MONTGOMERY COUNTY HISTORIC PRESERVATION COMMISSION
STAFF REPORT

Address:	7823 Overhill Rd., Bethesda	Meeting Date:	10/13/2021
Resource:	Contributing Resource Greenwich Forest Historic District	Report Date:	10/06/2021
Applicant:	Michael Bern & Rachel Roth Luke Olsen, Architect	Public Notice:	9/29/2021
Review:	HAWP	Tax Credit:	n/a
Permit No.:	967939	Staff:	Dan Bruechert
Proposal:	Building Addition and Accessory Structure Construction and Other Alterations

STAFF RECOMMENDATION

PROPOSED SITE PLAN

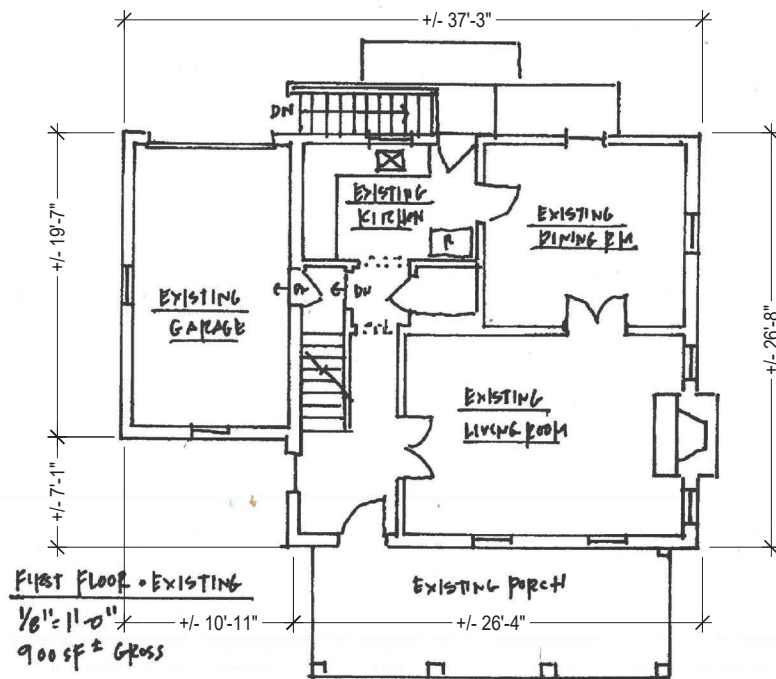
There are three final elements of the project that require HPC approval: removing a 15" d.b.h. tree on the north property boundary, constructing a 400 ft² stone patio to the east of the addition, and a retaining wall along the north property boundary.

Staff finds the proposed tree removal will not impact the character of the site or surrounding district. The proposed tree is the fourth in a row between the subject property and the property to its north, so its removal may not be noticeable. Guideline D15 is very prescriptive about tree removals and states that two trees from the list provided must be planted to mitigate the loss of a tree. No tree species or planting location was included on the submitted site plan. Staff recommends the HPC include a condition for approval that the applicant identifies the species and location of the requisite tree plantings on the plans submitted for permitting.

Second, the applicant proposes to install a new patio with a walkway. The total paving area is approximately 500 ft². Staff is not opposed to a patio in this location, as it is behind the house and addition so as not to be visible from the right-of-way. However, some details are missing and staff finds this portion of the project is incomplete. First, no materials for the proposed patio or walkway were included with the application. To thoroughly analyze the proposal materials and dimensions need to be submitted to the Staff for review. Second, Principle A1 of the *Guidelines* states that extensive impermeable hardscape surfaces should be avoided whenever possible to limit runoff into the Chesapeake Bay. Staff recommends that any approval does not extend to the proposed patio and that the applicant returns for either an amended HAWP or a stand-alone HAWP for the patio.

Finally, the site plan shows a retaining wall to be constructed to the north of the driveway near the proposed garage. The previous HAWP approved a retaining wall in this location and Staff finds that it is an appropriate location to help control runoff, however, materials and dimensions were not included with the application. Staff recommends that the HPC approve the location of the retaining wall and delegate final approval authority of a compatible material to Staff.

1. The proposed tree removal is approved, however, the species, from the list of Guidelines D15, and the location of two tree plantings need to be identified on the site plans submitted for permit

2. Details for the patio are incomplete and approval of this HAWP does not extend to the patio. Material specifications, dimensions, and any runoff mitigation needs to be submitted for review and approval either as an amendment to this HAWP or as a stand-alone HAWP.
3. The retaining wall to the north of the driveway did not include a proposed material. Final approval authority of a compatible material for this retaining wall is delegated to Staff;
